Technical Service Bulletin Number	Revision Level	Date	Group Number
TSB130159

Fault Code 3167 or 1691 Caused by a Missing Poppet in the EcoFit™ Aftertreatment Fuel Injector

Missing Poppet - EcoFit™ Aftertreatment Fuel Injector

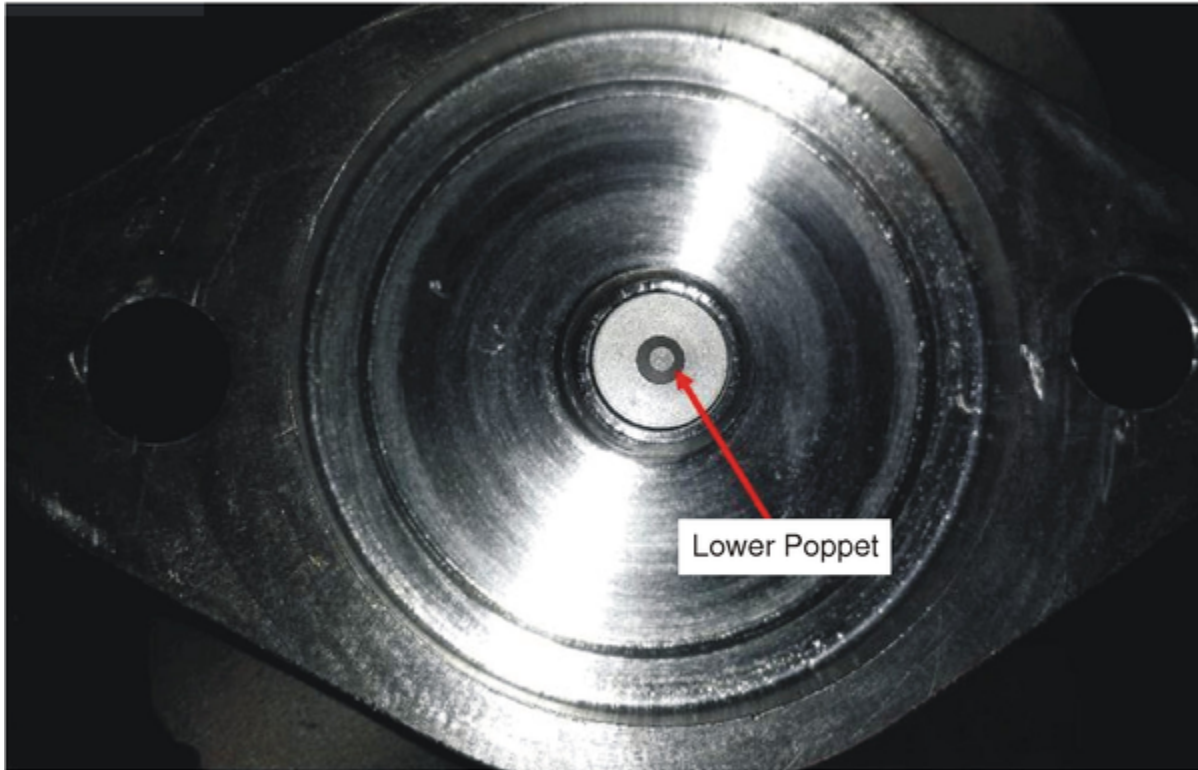
Malfunctioned EcoFit™ aftertreatment fuel injectors will have a hole in the center of the injection point. A normal EcoFit™ aftertreatment fuel injector will have a visible plunger (poppet) at the center of the injection point.

If the EcoFit™ aftertreatment fuel injector is missing the lower poppet, replace the aftertreatment fuel injector.
